SSD 9227: RESPONSE TO SUBMISSIONS, PROPOSED AMITY COLLEGE SCHOOL CAMPUS AT No.85 BYRON ROAD AND No.63 INGLEBURN ROAD, LOTS 1 & 2 DP 525996, LEPPINGTON, NSW

1. Overview: Submissions Made to Exhibited EIS

FIGURE 2.1: Satisfactory bus swept paths entering and exiting proposed bus bay Byron Road
(Source: Traffic report- refer Appendix D for details)

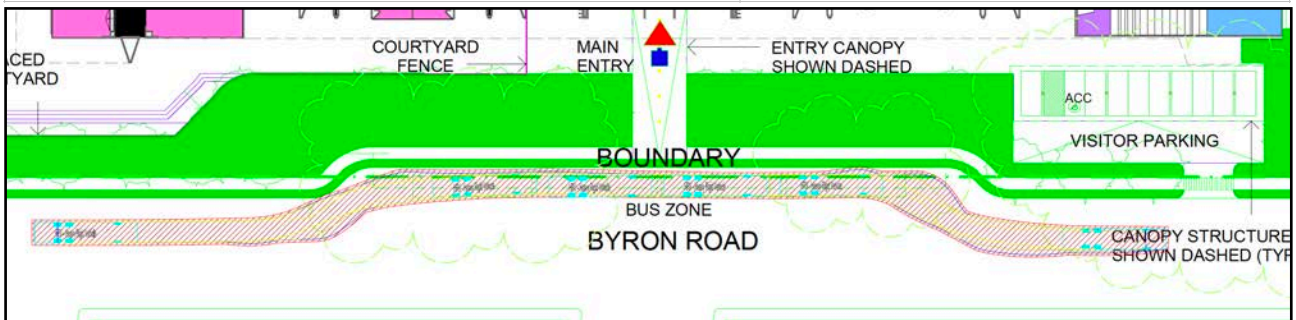
Issue Raised in Transport for NSW Submission	Response
Short-term bus accessibility ▶ "DPIE should note that school bus access (for standard bus sizes) to the site may not be possible until such time that Byron Road and relevant sections of Heath Road are upgraded to reflect the intended design per the Camden Growth Centres Precincts Development Control Plan."	Noted. Stage 1 of the school development provides for smaller bus access to the primary school, accessed from the upgraded southern Local Road (Pluto Road). Roadworks on Byron Road and the provision for larger buses is planned for Stage 3 of the school project.
Bus bay length ▶ The swept path analysis should demonstrate the ability for any of the five buses to exit out of the bus bay. ▶ "The swept path analysis should be revised to address the comment above and the design of the bus bay should be amended accordingly."	Noted. To clarify, the bus bay provides for four (4) buses, not five. Refer to advice from traffic consultants Traffix in Appendix D , which includes a swept path analysis that confirms that buses can safely enter and exit the proposed bus bay on Byron Road. Refer Figure 2.1 .

FIGURE 2.2: Bicycle parking spaces clearly identified in Ground Floor plan

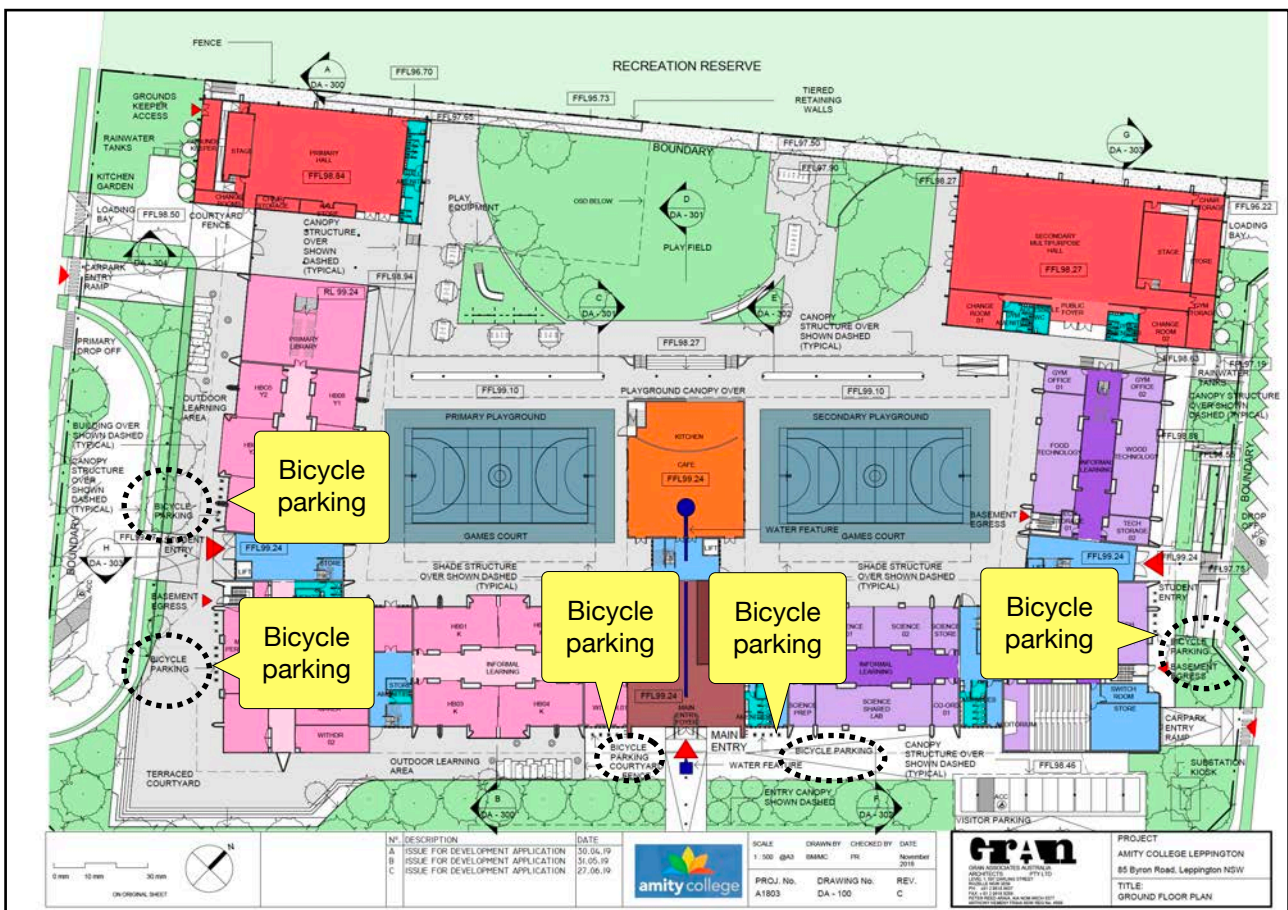
- ▶ “Section 5.3 of the Traffic Impact Assessment states that the development proposes 62 bicycle parking spaces. However, a review of the architectural drawings (Appendix C of the EIS) does not indicate the proposed location of these parking spaces.”
- ▶ “It is recommended that the Applicant amends the development plans to include the proposed 62 bicycle parking spaces. The location of the spaces should be easily accessible from the site’s pedestrian access points .”

The 62 bicycle parking spaces proposed are clearly shown on the DA drawings in Appendix B of the exhibited EIS namely: Ground Floor Plan Drawing No. DA-100 Revision C, and Basement Floor Plan Drawing No. DA-105 Revision B.

Refer to accompanying DA drawings with proposed bicycle spaces highlighted- refer **Figure 2.2** and **Figure 2.3**.

FIGURE 2.3: Reticulated water services to be provided to proposed school

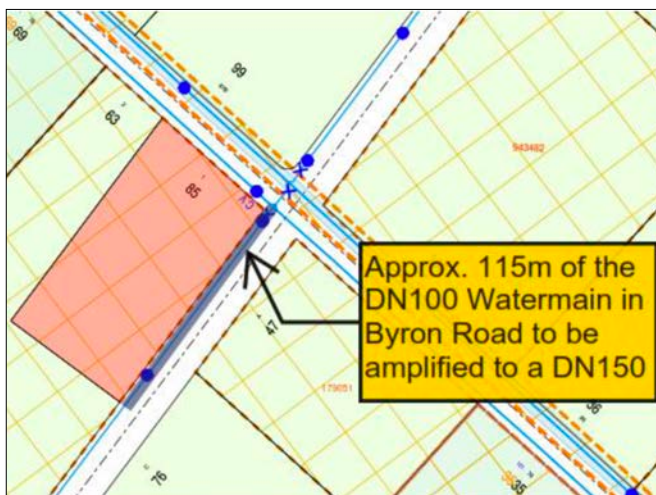
- The developer will be required to construct a 150mm water main along the full frontage of Byron Road to service this development. These works must be constructed by a constructor with the appropriate capability. The Water Servicing Coordinator will be able to provide further advice about this.

Refer **Appendix F** and to **Figures 2.3** and **2.4**, below.

FIGURE 2.4: Sewer connections to be provided to proposed school

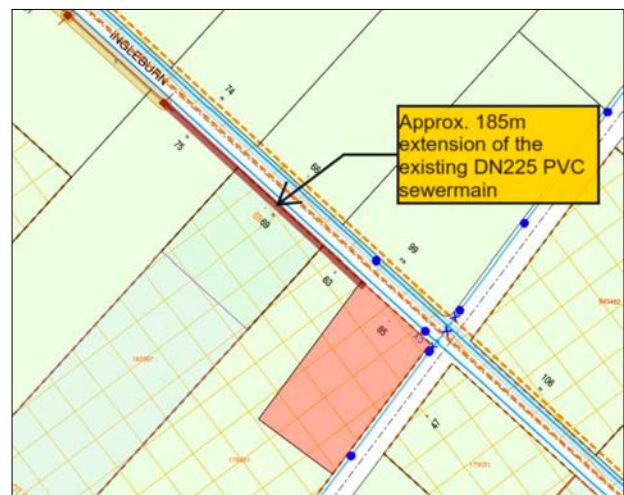
The submission received from Sydney Water is contained in a letter to the Department of Planning Industry & Environment dated 27 September 2019 and is addressed below. Sydney Water advises as follows:
